February 2nd, 2017
Peru State College, Theatre and Event Center Renovation and Addition
Peru, Nebraska

ADDENDUM #2

1 FIRST FLOOR CEILING
A3.1 1/8" = 1'-0"

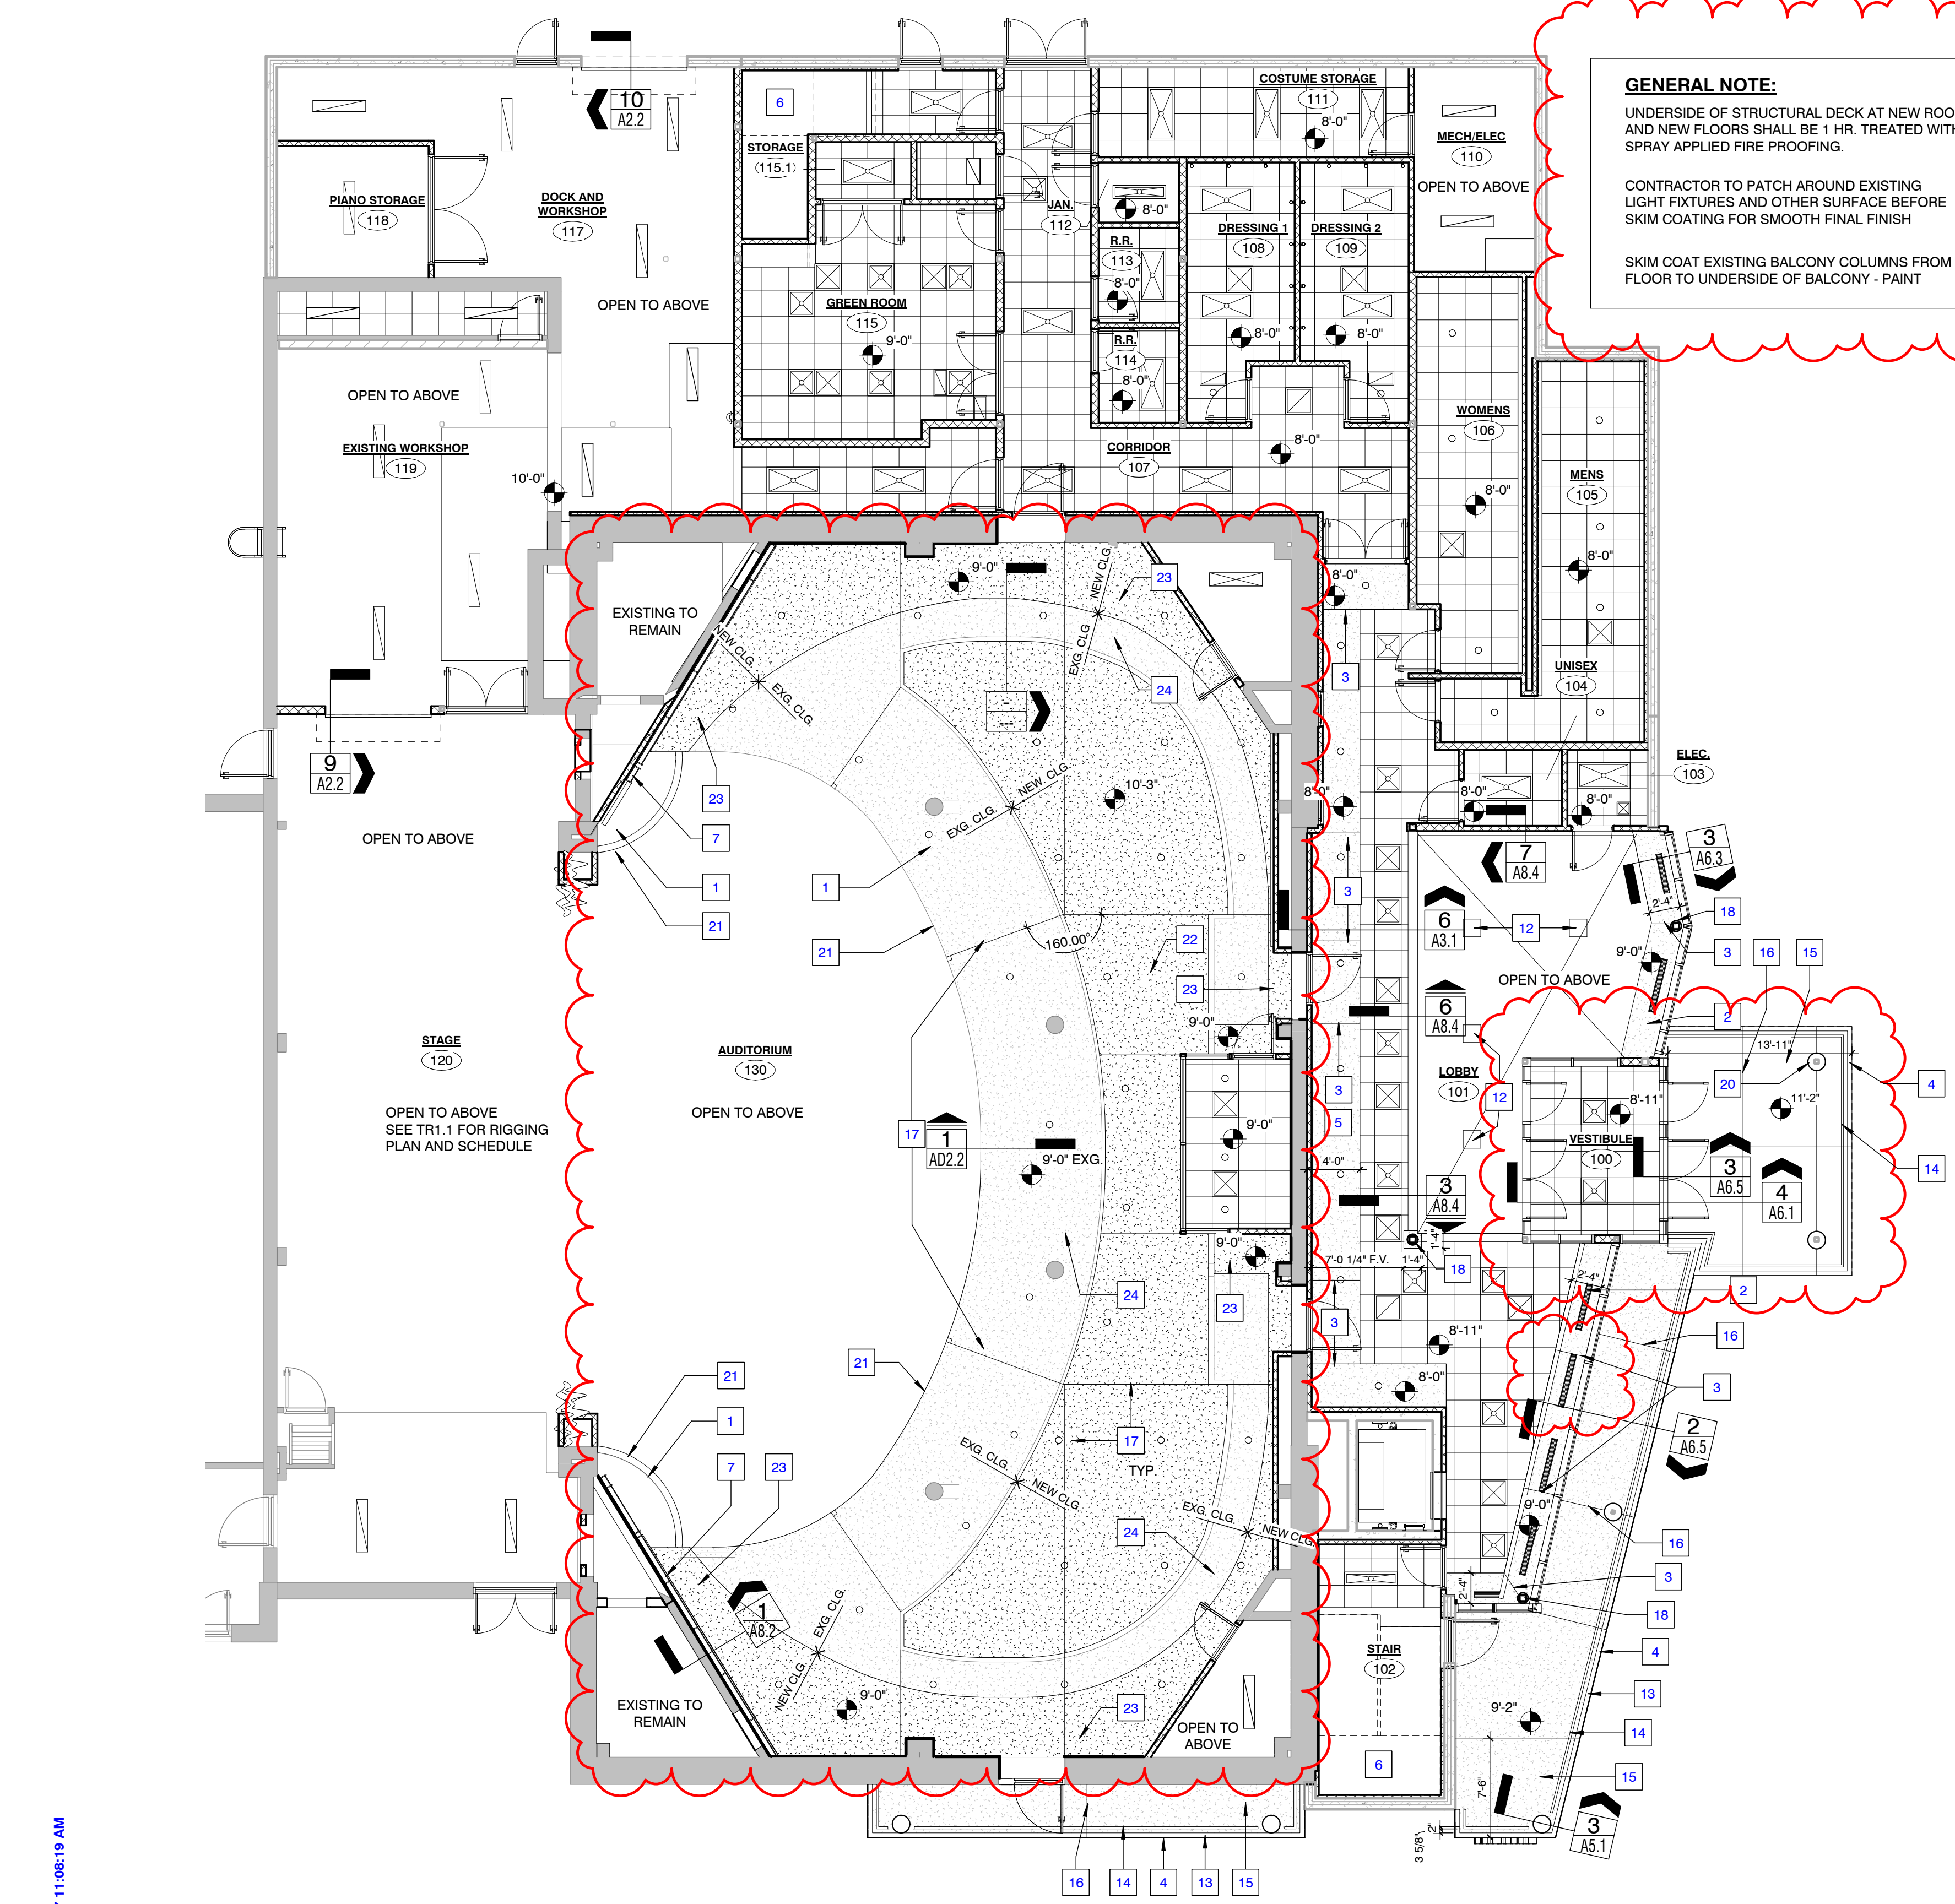
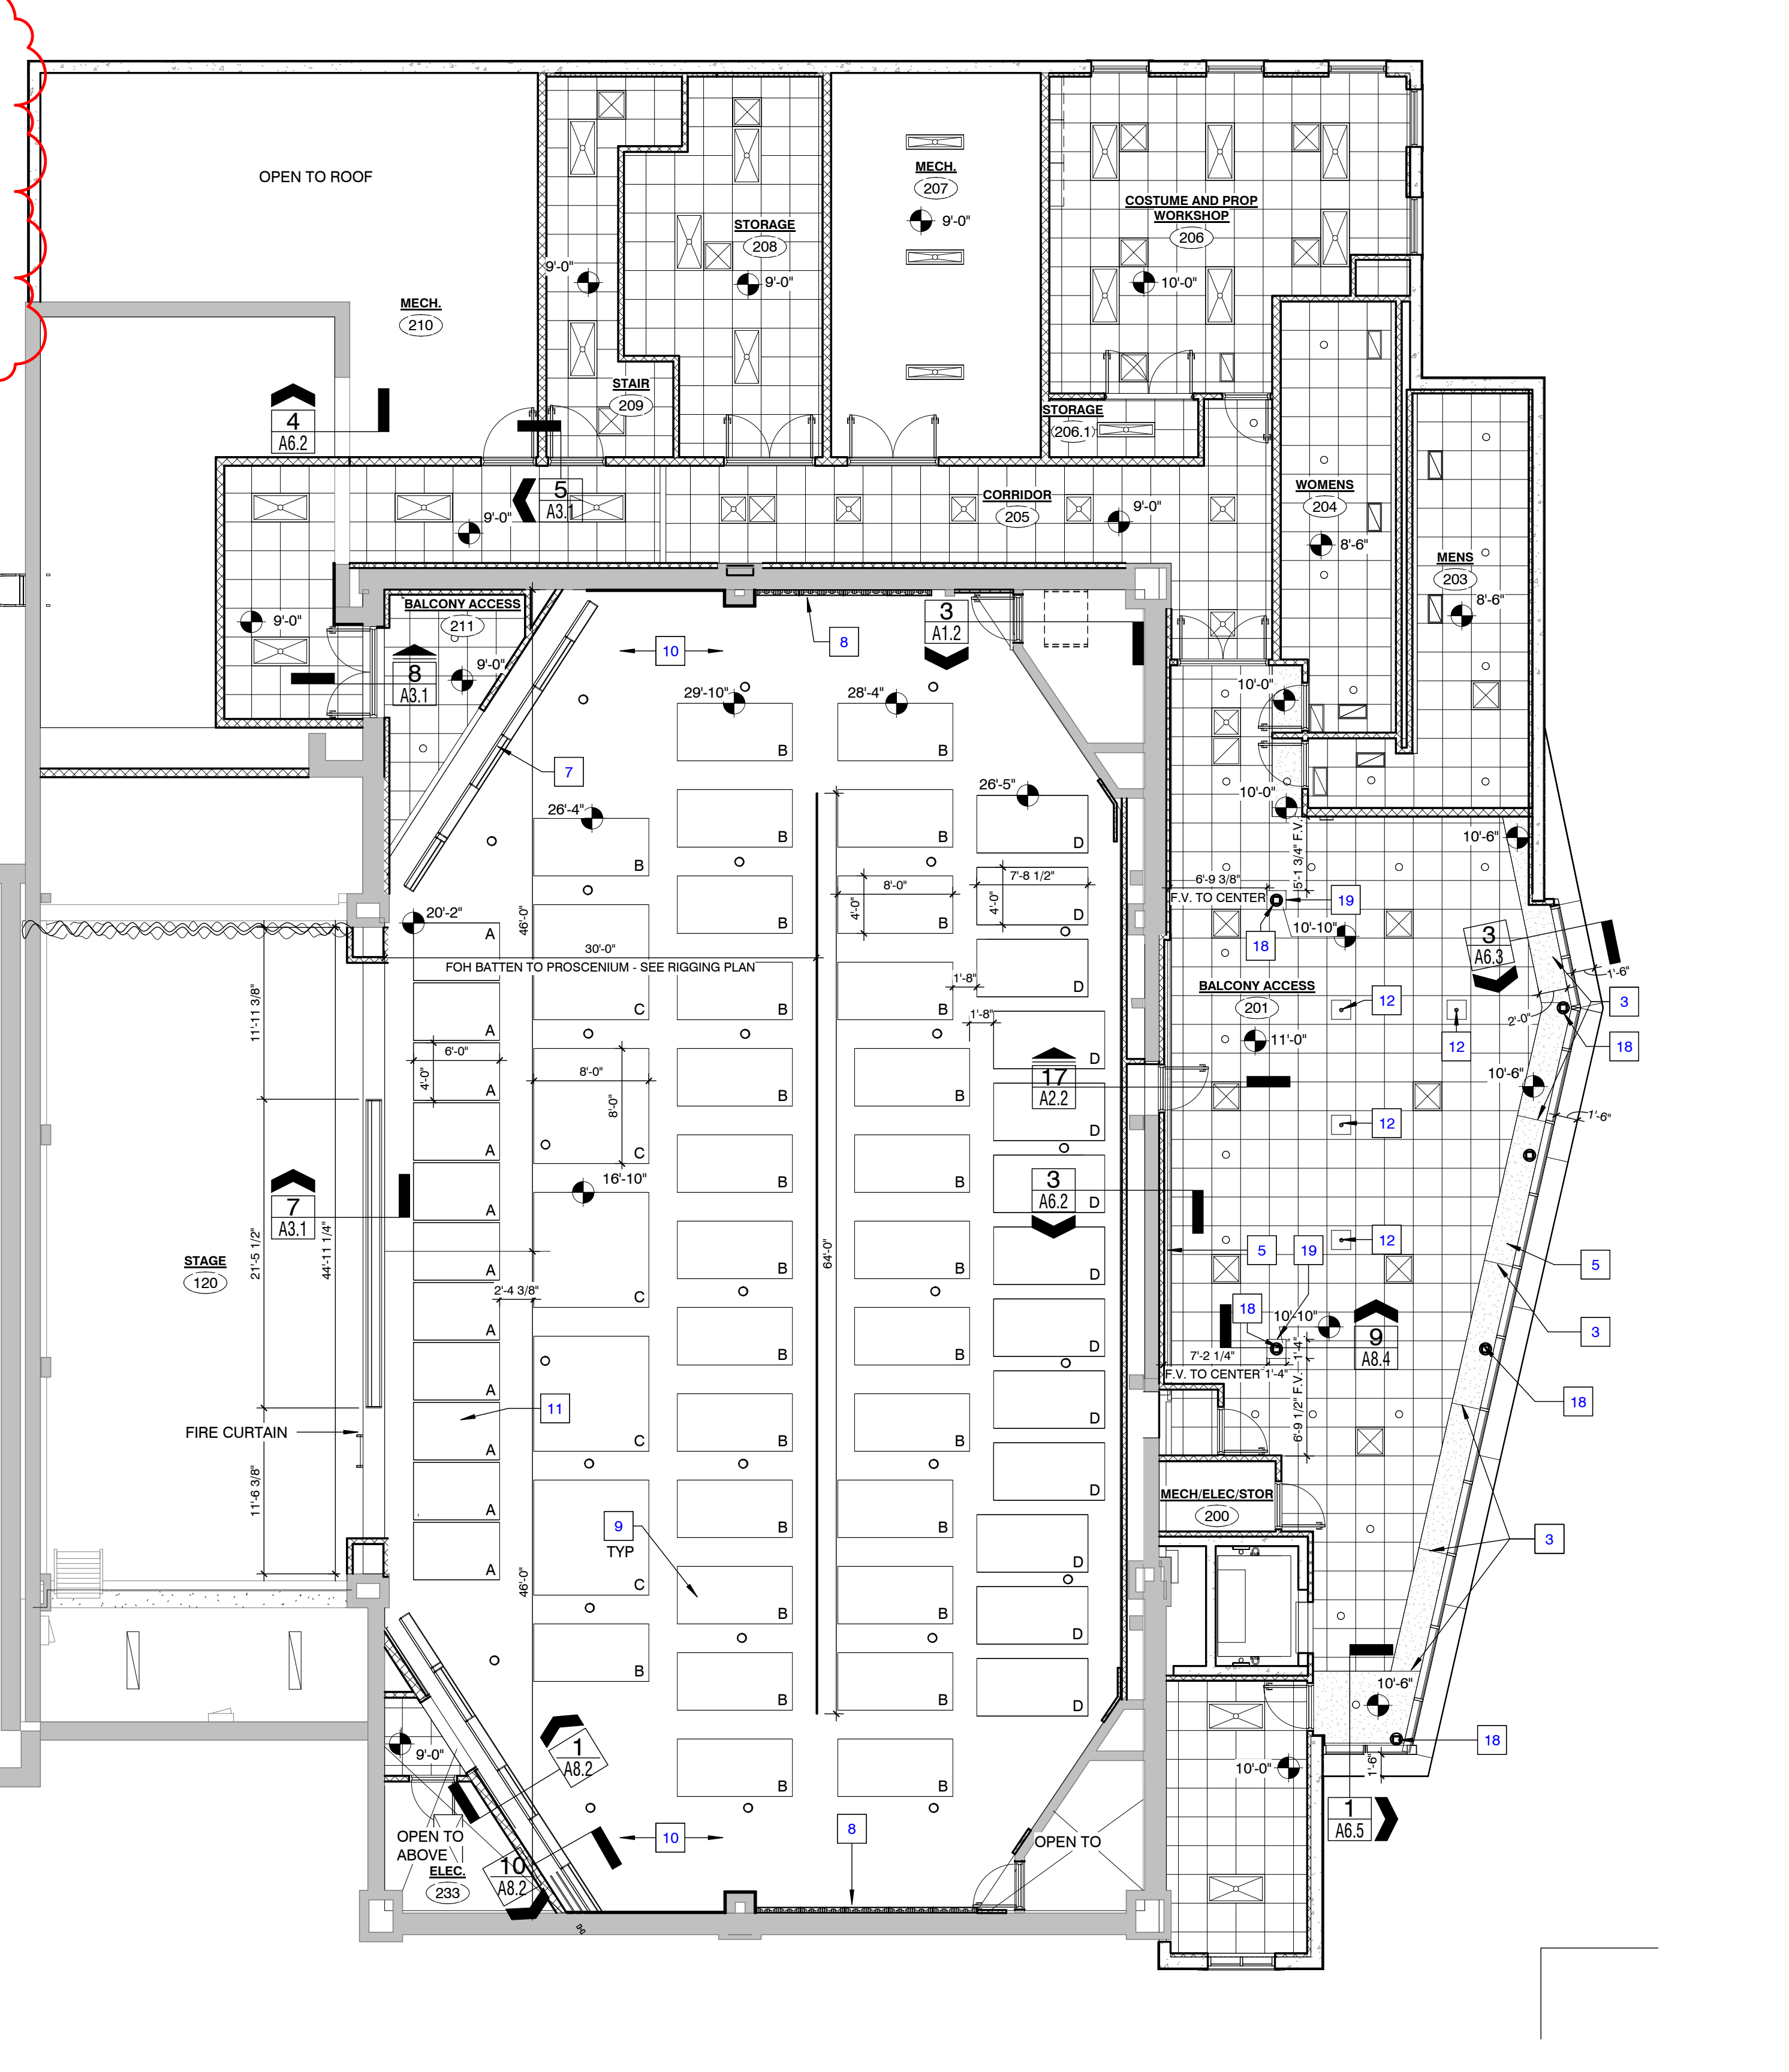
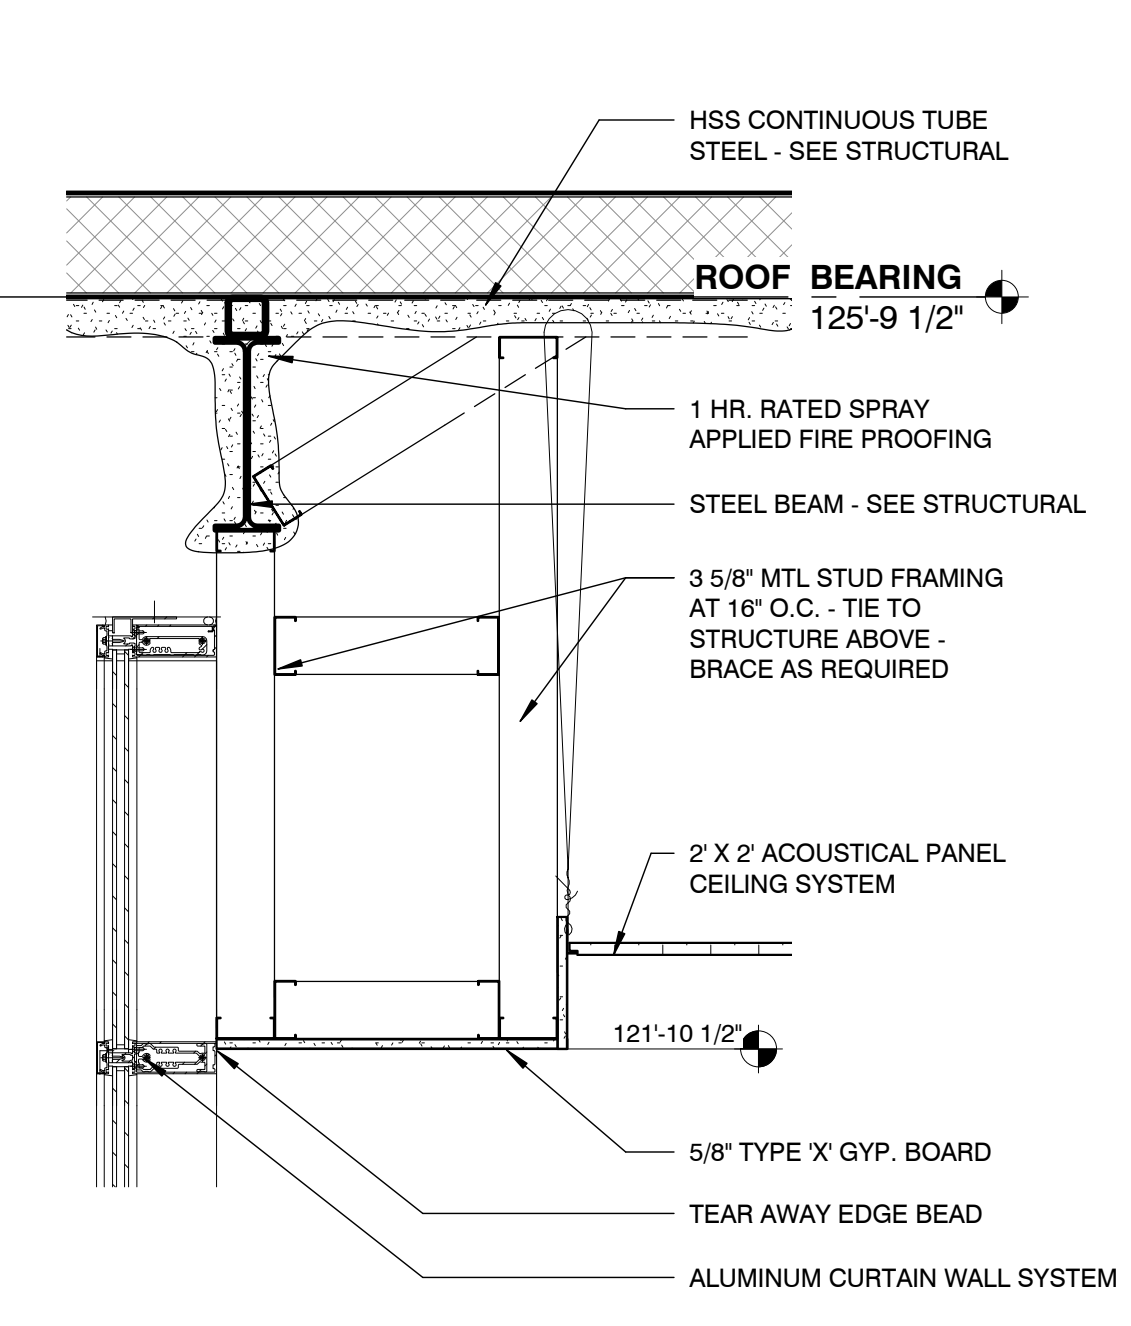
- A. See attached revised sheet A3.1

There's a conflict between 1161 00.203.A.1 ("motorized straight lift type, automatically closing fire safety curtain") and drawing.

The Curtain assembly shown 7/A3.1 is inaccurate, the specified fire curtain assembly will need electrical to be routed to the top of rigging grid.
